Donnybrook-Woodstock Infrastructure Contributions Plan

Part A (Part 2) Submission

Amendment GC102 to the Whittlesea and Mitchell Planning Schemes

October 2019

Figure 20 Recommended revision to Plan 2 of ICP to reflect the revised designs for the Donnybrook Road intersections

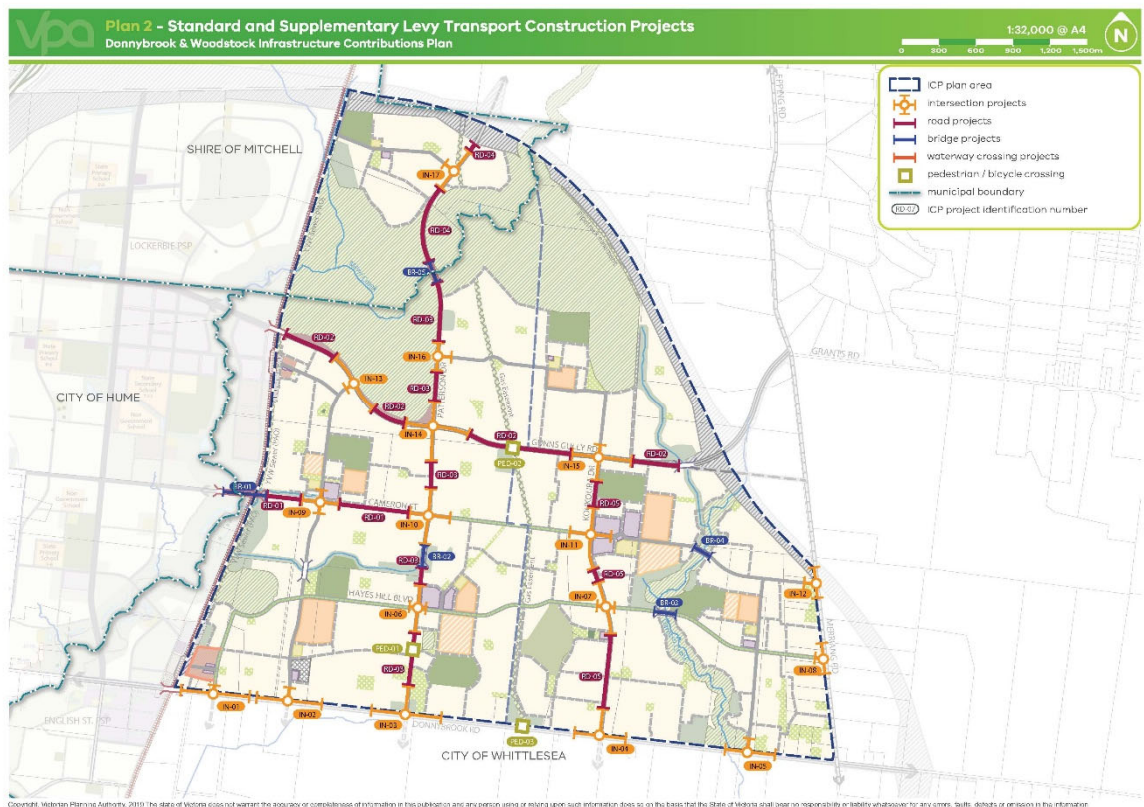
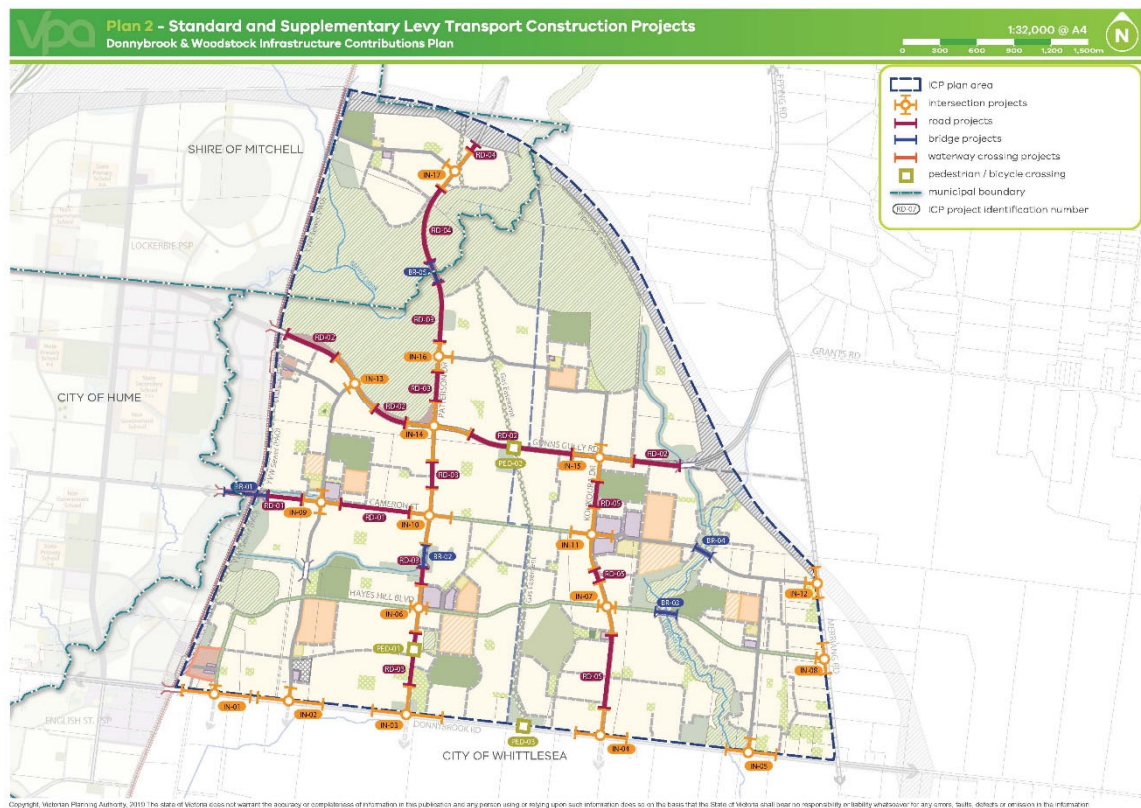
- Plan 2 of the ICP will be updated to depict these intersections as T-intersections (see Figure 20 below).
- The description of these intersections in Table 5 and 6 of the ICP will be “3-way” not “4-way” (discussed in section 8.3.5)
- The apportionment of the T-intersections to the Donnybrook-Woodstock ICP will be 100% (the exhibited ICP apportioned 75% of a cross-intersection to the ICP and 25% to the Shenstone Park ICP).
- Minor public purpose land area changes are required for IN-03 and IN-04, each intersection affecting the two parcels being 19 and 20, and 32 and 33 respectively, in addition to parcel 33 also being affected by public purpose land area changes for RD-05. The overall public purpose land by 0.12 hectares as shown in

Figure 21 Change in the design of IN-16 (benchmark item 15) from the July 2018 to the April 2019 Benchmark Costings

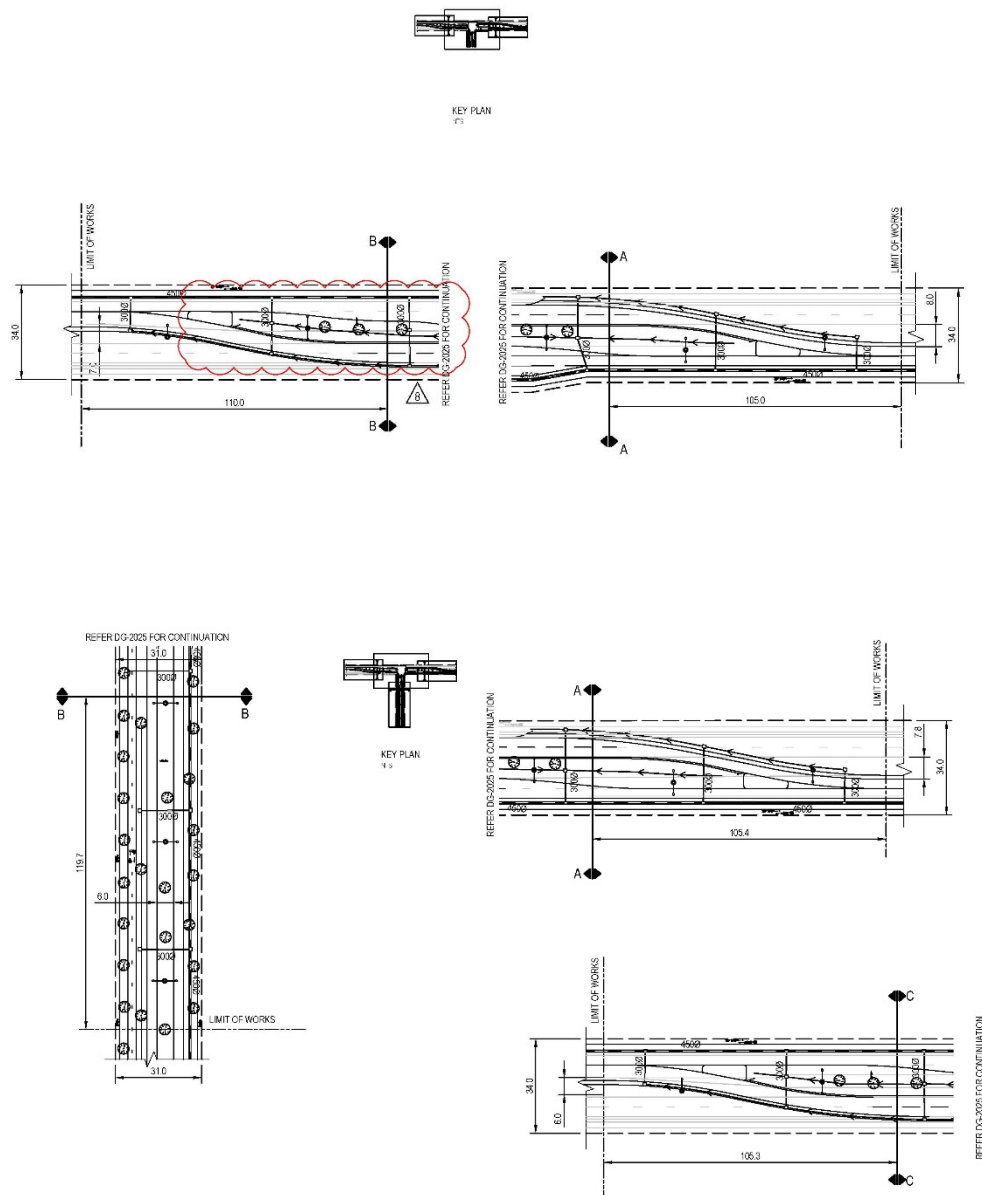
The design change for IN-16, being benchmark item 15, is shown in the Figure 21 below. The difference between the two designs is the reduced length of the connector leg, which thereby reduces the total area required for the design. This means the subject 0.31 ha on parcel 8 will be deducted from the "parcel contribution total" of 9.9919 ha identified in Table 3 of the ICP and will be added to the net developable area of this parcel.

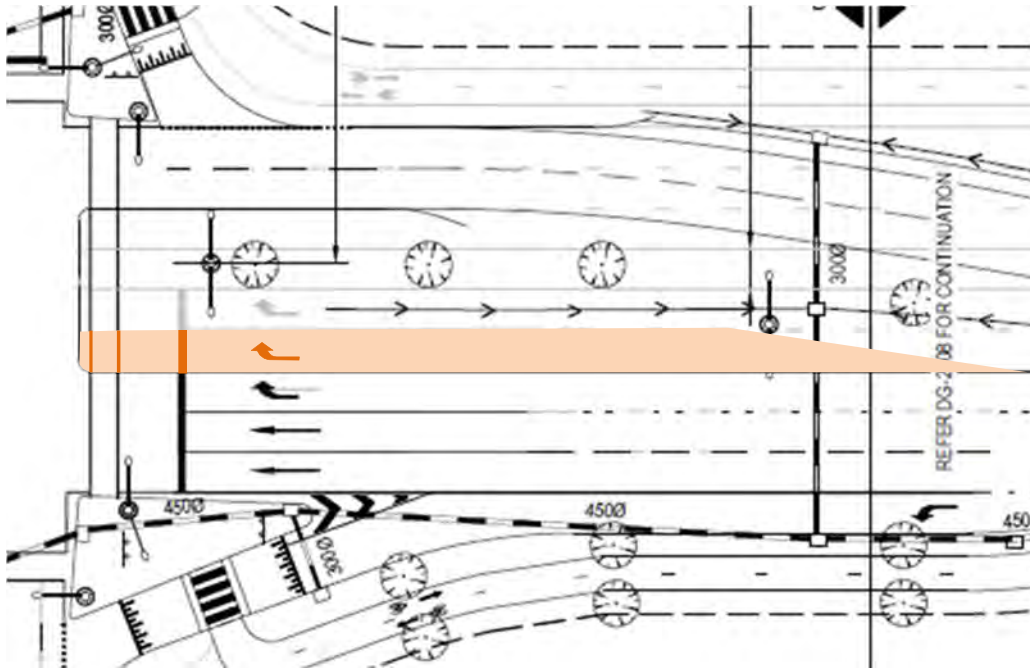
An additional right turn lane has been agreed to by all parties at a primary-secondary intersection due to unusually high expected turning movements.

EXHIBITED ICP
(AUG2018)

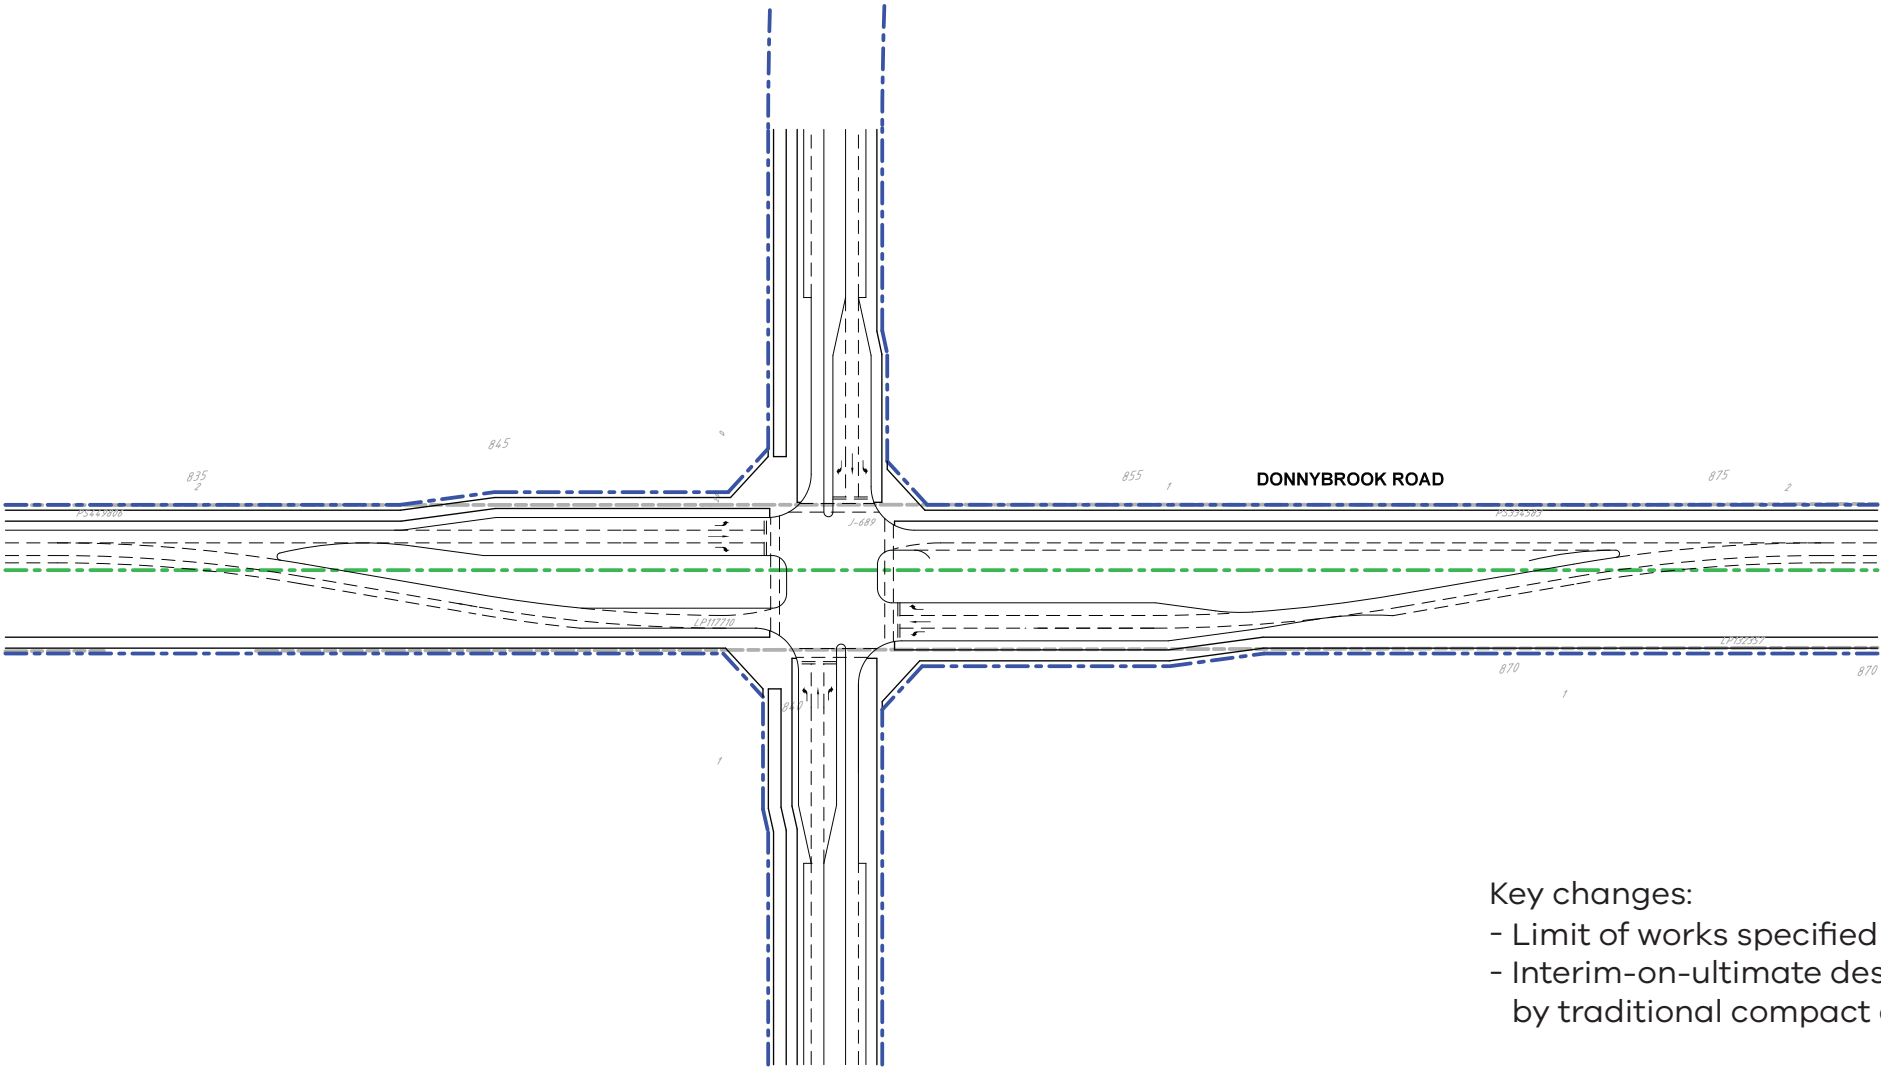
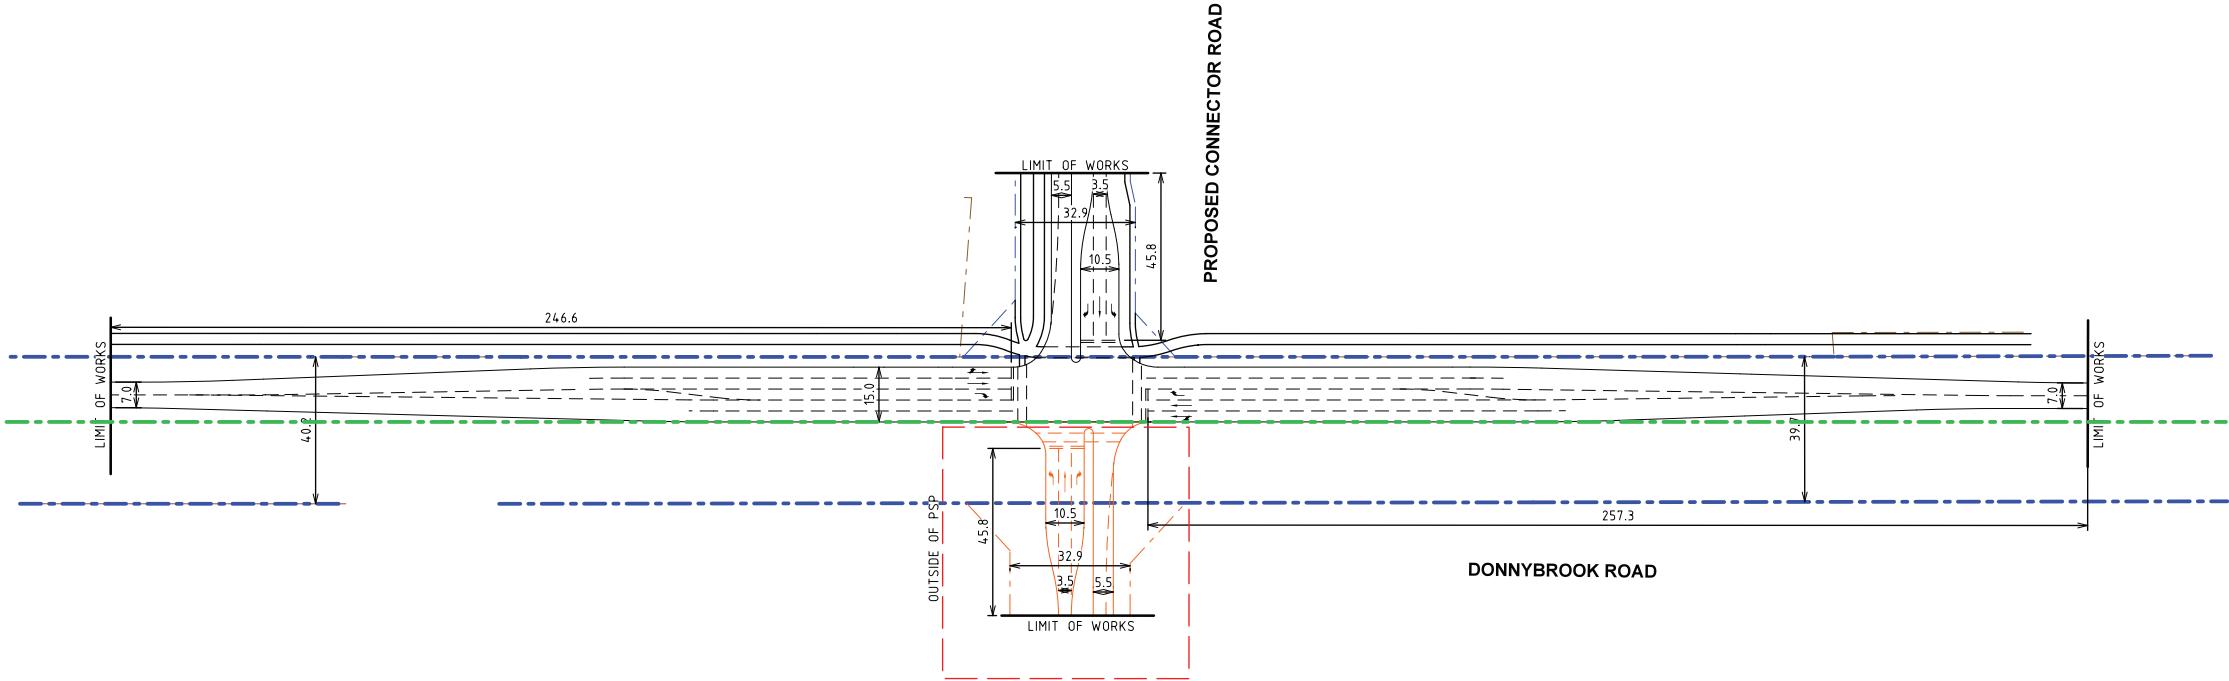
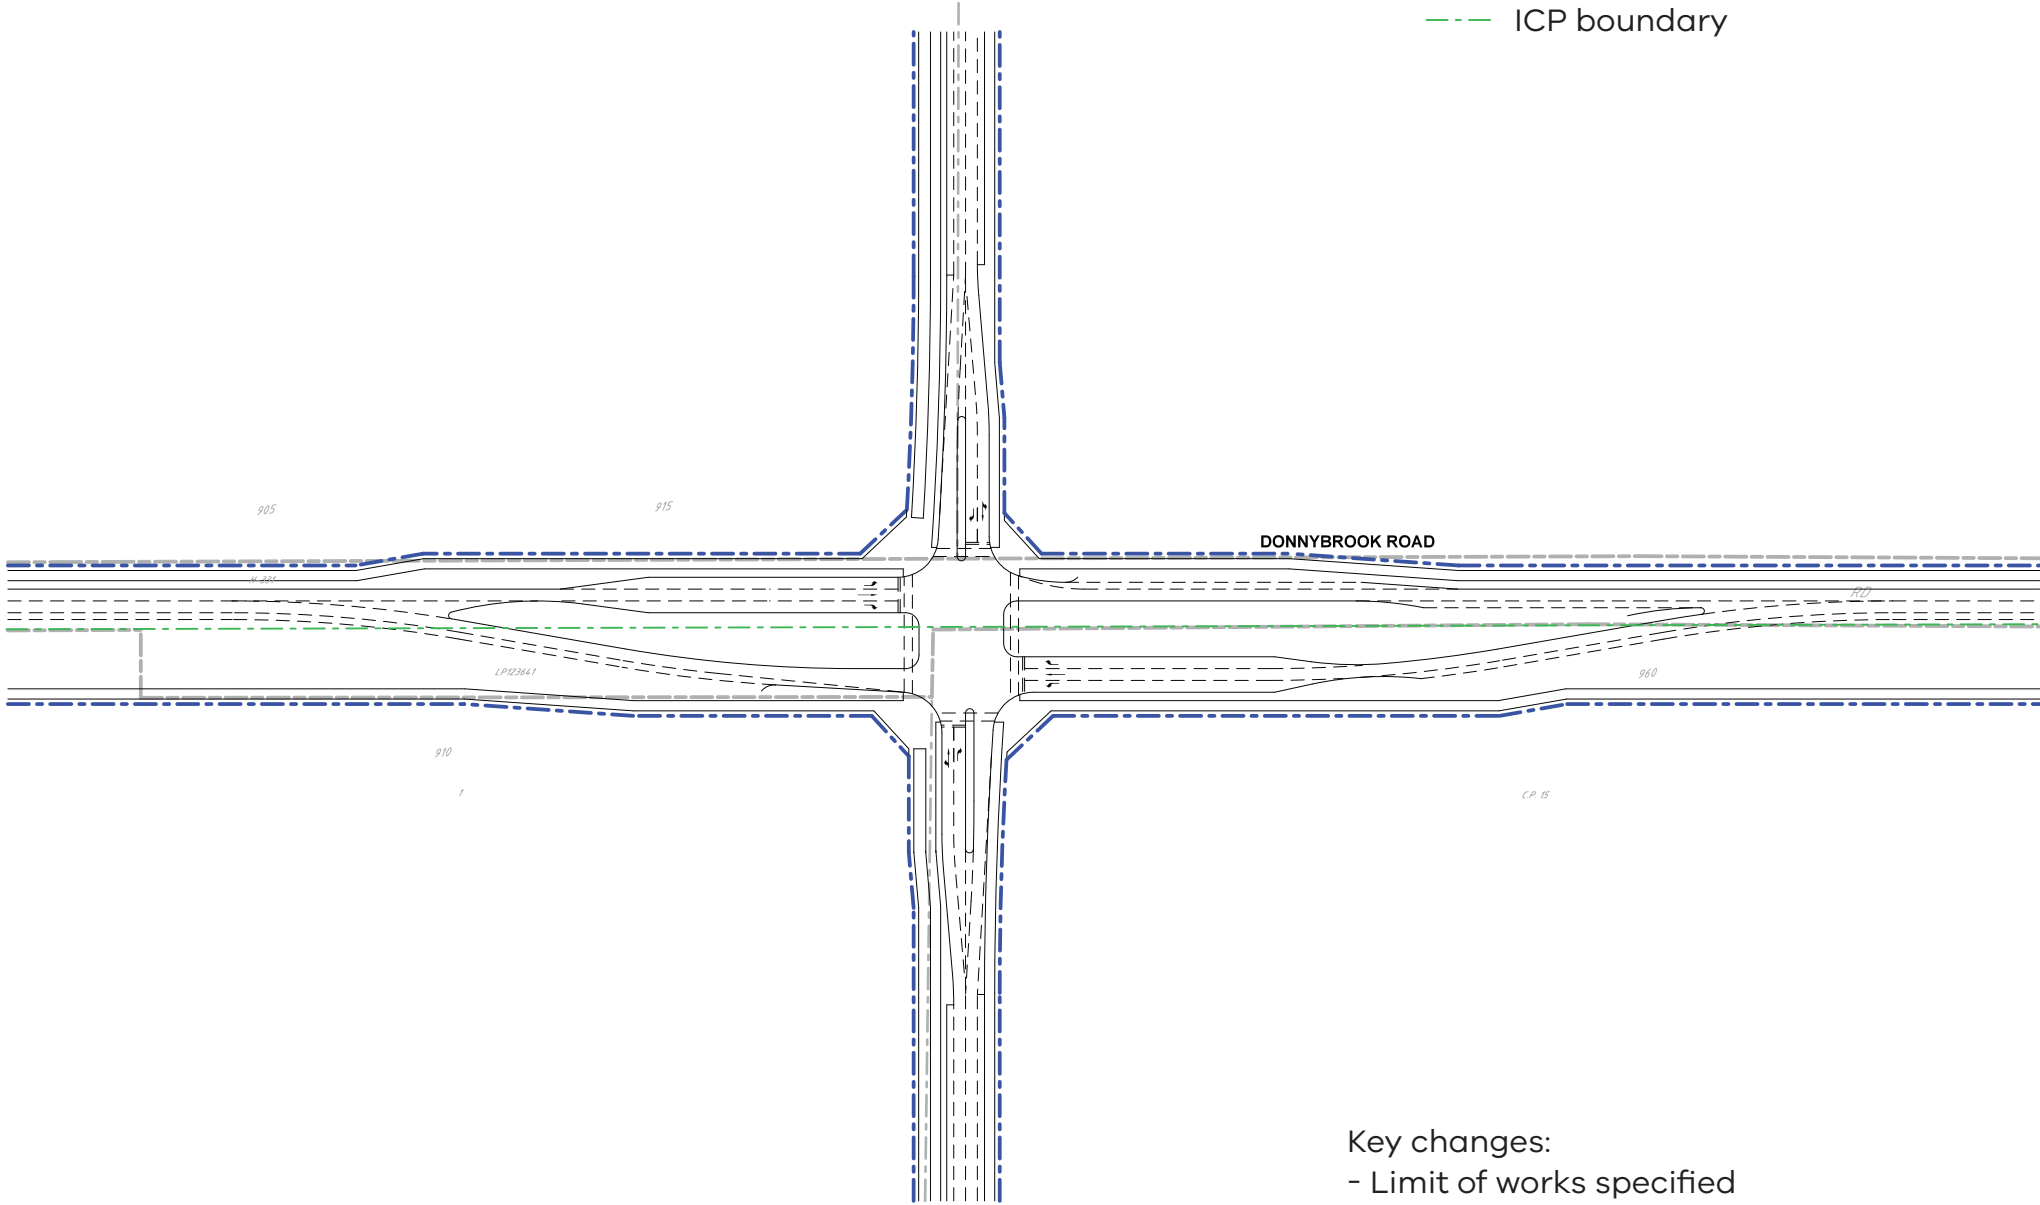
- Key changes:
- Limit of works specified
 - Interim-on-ultimate design replaced by traditional compact design
 - Relocated to the west from exhibited position
